APPEAL SUMMARY

Appeal ID: 20546	Project Address: 1600 SW Salmon St
Hearing Date: 6/19/19	Appellant Name: Tom Jaleski
Case No.: B-017	Appellant Phone: 503.488.5651
Appeal Type: Building	Plans Examiner/Inspector: Jody Orrison
Project Type: commercial	Stories: 6 Occupancy: A-2, A-3, B, E, S-1 Construction Type: I-B
Building/Business Name: Lincoln High School	Fire Sprinklers: Yes - Throughout
Appeal Involves: Erection of a new structure	LUR or Permit Application No.:
Plan Submitted Option: pdf [File 1] [File 2]	Proposed use: High School - Main Building

APPEAL INFORMATION SHEET

LINCOLN HIGH SCHOOL REPLACEMENT

Copyright 17011
100% DESIGN
DEVELOPMENT
STAIR 4 ENLARGED
PLANS

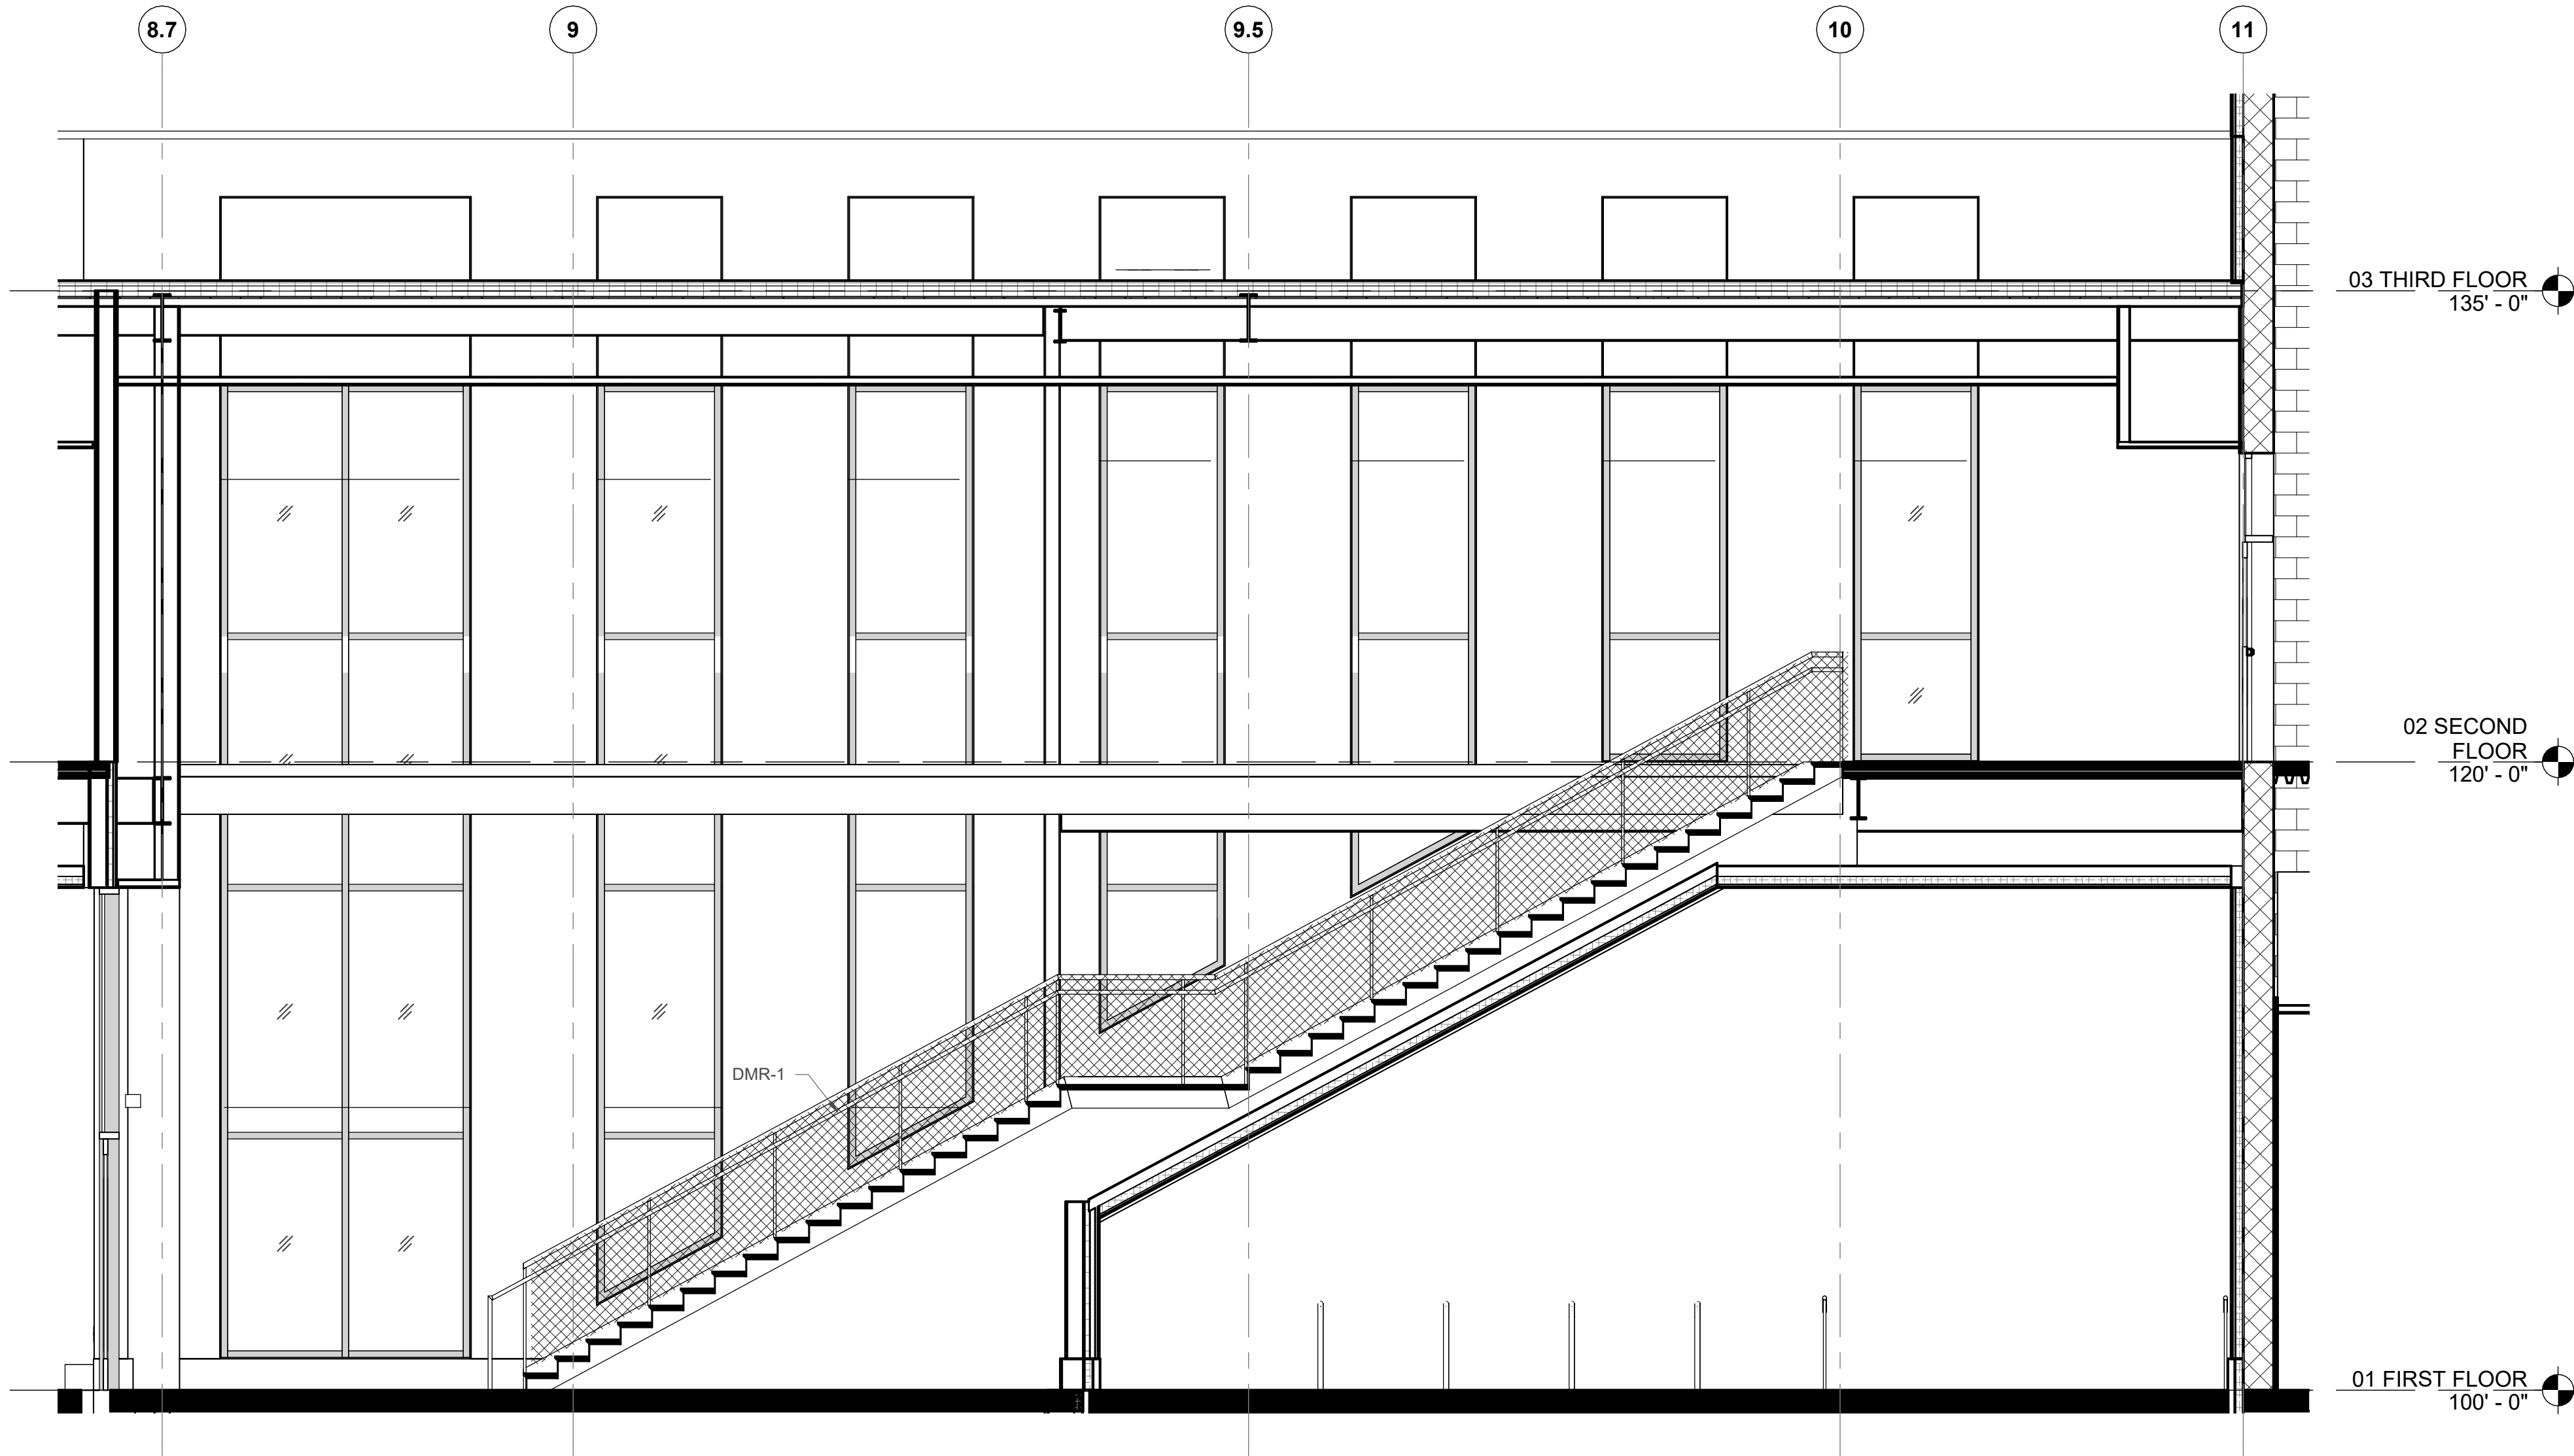
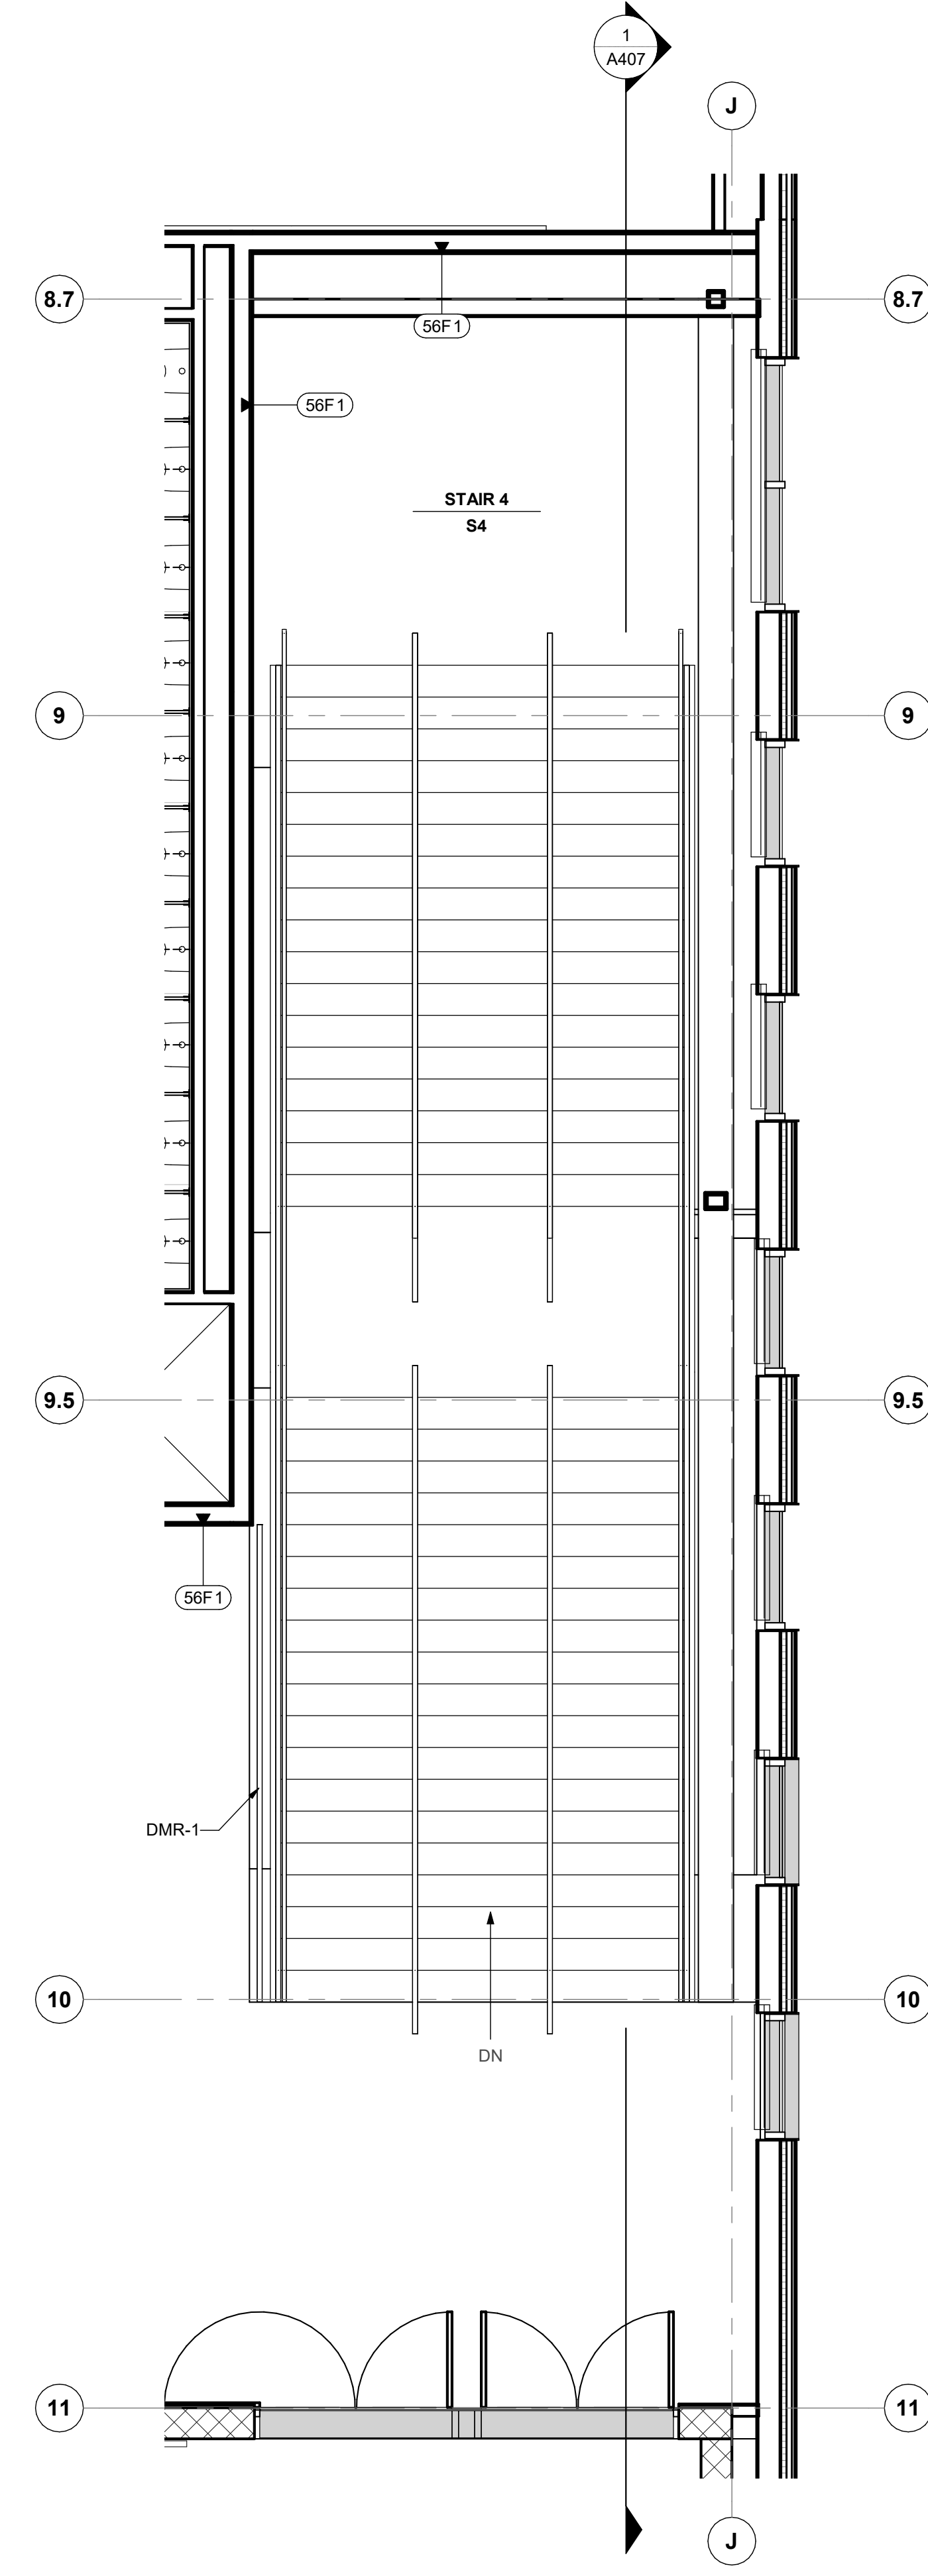
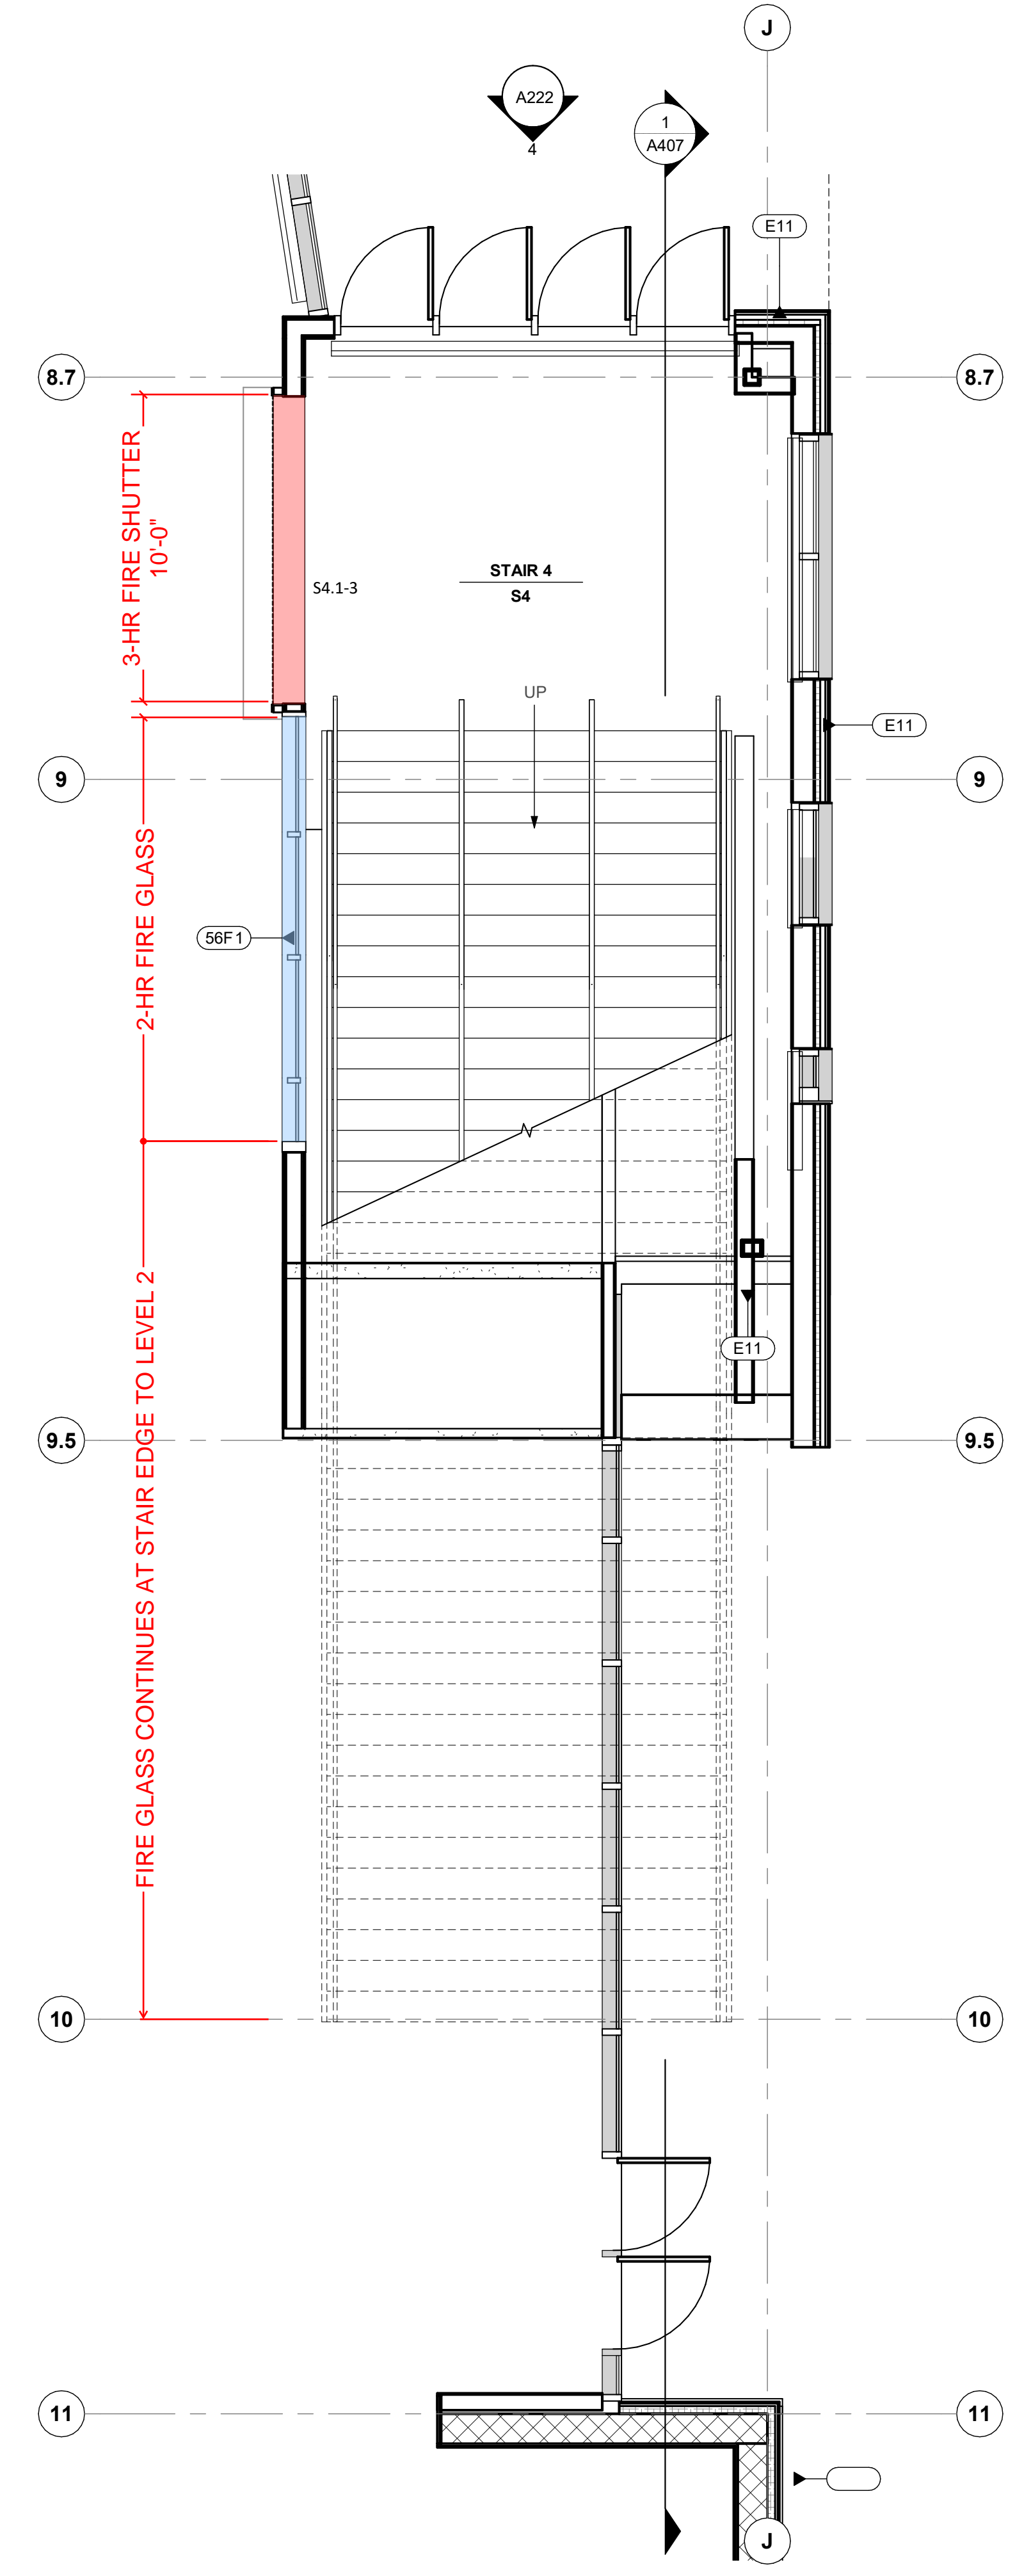
Stair 4:

- CONDITION: Two-story exit access stairway.
 - RATING: 2-hour fire-resistance-rated construction at Level 01 to maintain Horizontal Exit at Level 2.
 - EGRESS: Four (4) egress doors from partial enclosure direct to the exterior.
- OPENING PROTECTION:
- o Two openings located on west wall of enclosure at Level 01.
 - o First opening protected with a 3-hour fire shutter meeting UL 10B (equivalent) and UL 1784, and provided with an automatic-closing device and smoke detection; 10-ft wide by 16-ft tall (160 sf).

o Second opening protected by 2-hour fire glass meeting ASTM E 119 or UL 263; size varies as it follows the edge of the stair run.

2a. The 2-hour fire-resistance-rated glazing located on the west wall of the Stair 4 enclosure is a prescriptively permitted opening.

2b. The 3-hour fire-resistance-rated fire shutters located on the west wall of the Stair 4 enclosure and on the west wall of the Stair 1 are not prescriptively allowed. The shutters will provide equivalent fire life safety as compared to the code requirements of a stairway enclosure in a fire event by meeting, and in some requirements exceeding, the opening protective provisions of Chapter 7 as follows:

Therefore, due to equivalent life safety protection being provided to meet the intent of §1009.3.1.4.1 and §1022.4, it is requested that the two (2) openings in Stair 1 and the two (2) openings in Stair 4 be permitted when protected with a 3-hour fire-resistance-rated fire shutter or 2-hour fire glass as identified in the proposed design.

2. Openings in (2) two hour fire rated stair enclosures: Hold for additional information.
